STAFF REPORT
(Preliminary Plat)

CASE NUMBER: S/D 96-29 WOODLAND HILLS 2ND ADDITION

STAFF REPORT

STAFF REPORT

VICINITY MAP:

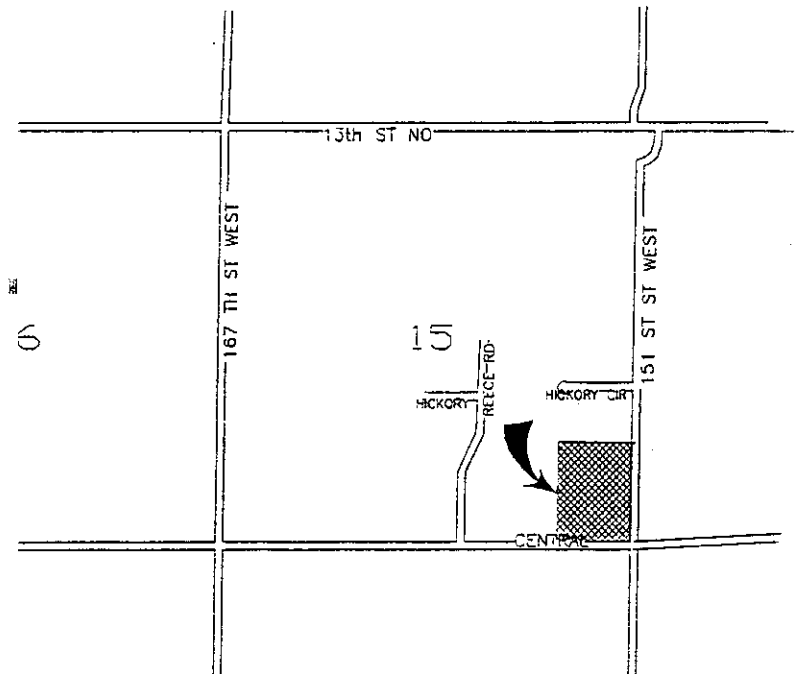
- A. The final plat tracing shall show a contingent dedication for the extension of Pine Circle to the west line of this site. Permanent 35-foot building setbacks shall also be platted from the contingent right-of-way. Either the face of the plat, or a separate document for recording shall be provided, which clearly indicates the conditions for this contingency. That is, if either Lot 2 or 3 desires to replat in the manner shown on the redevelopment/sketch plan, the associated street on the adjacent lot shall become a dedicated street.

- B. Because the location of a home on the lots being platted could possibly effect the potential of the redevelopment plans as shown, the applicant shall submit a means by which the location of a home and any related structures can or will be restricted so as not to interfere with the possible installation of future streets and the typical 25-foot building setback from such streets. That is, by way of a covenant or other acceptable means, the applicant needs to establish controls on how the four lots now being platted can be used in order to assure that the indicated redevelopment plan can actually be implemented.

- C. In regard to the potential development plan, County Engineering needs to indicate if any additional guarantees for drainage, street improvements, etc. should be required at this time.

VICINITY MAP:

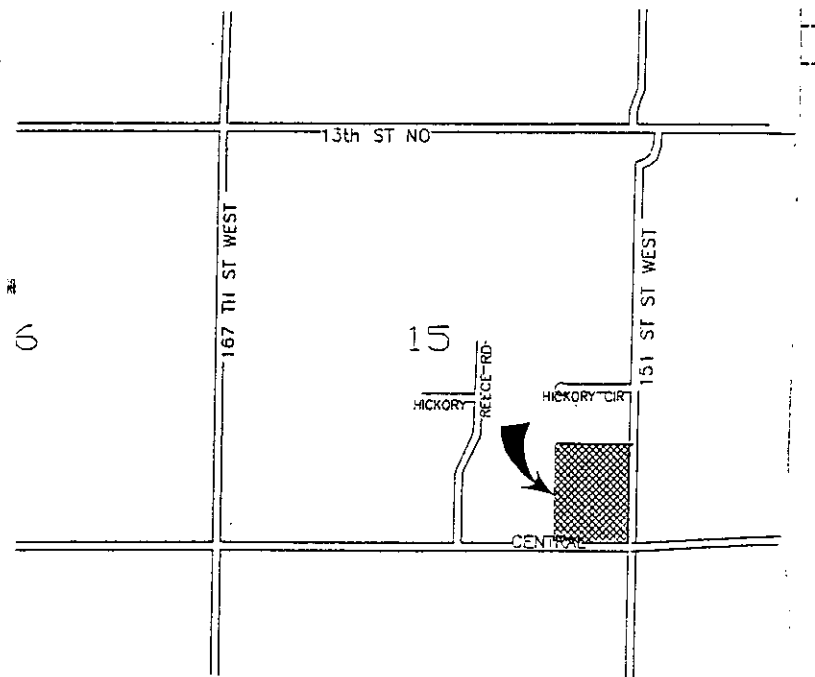
- A. The final plat tracing shall show a contingent dedication for the extension of Pine Circle to the west line of this site. Permanent 35-foot building setbacks shall also be platted from the contingent right-of-way. Either the face of the plat, or a separate document for recording shall be provided, which clearly indicates the conditions for this contingency. That is, if either Lot 2 or 3 desires to replat in the manner shown on the redevelopment/sketch plan, the associated street on the adjacent lot shall become a dedicated street.

- B. Because the location of a home on the lots being platted could possibly effect the potential of the redevelopment plans as shown, the applicant shall submit a means by which the location of a home and any related structures can or will be restricted so as not to interfere with the possible installation of future streets and the typical 25-foot building setback from such streets. That is, by way of a covenant or other acceptable means, the applicant needs to establish controls on how the four lots now being platted can be used in order to assure that the indicated redevelopment plan can actually be implemented.

- C. In regard to the potential development plan, County Engineering needs to indicate if any additional guarantees for drainage, street improvements, etc. should be required at this time.

VICINITY MAP:

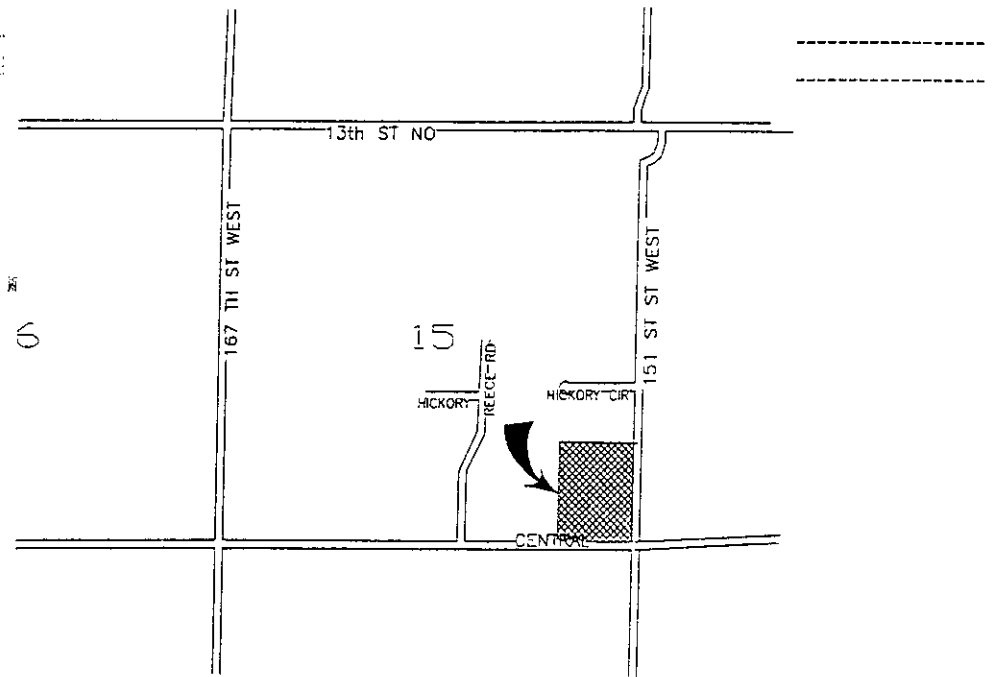
- E. In regard to the potential development plan, **County Engineering** needs to indicate if any additional guarantees for drainage, street improvements, etc. should be required at this time. That is, since the resubdivision of any one lot could/would involve improvements impacting other lots in this Addition, can/should guarantees (i.e., petitions) be required at this time which would obligate other properties to participate in such improvements.

- E. On the final plat tracing, the MAPC signature block shall indicate John C. Frye as chairman.
- G. The applicant needs to resolve an apparent error in the spelling of the name shown on the plat and in the platting binder as to the site's ownership (Falkawski vs. Falkowski).
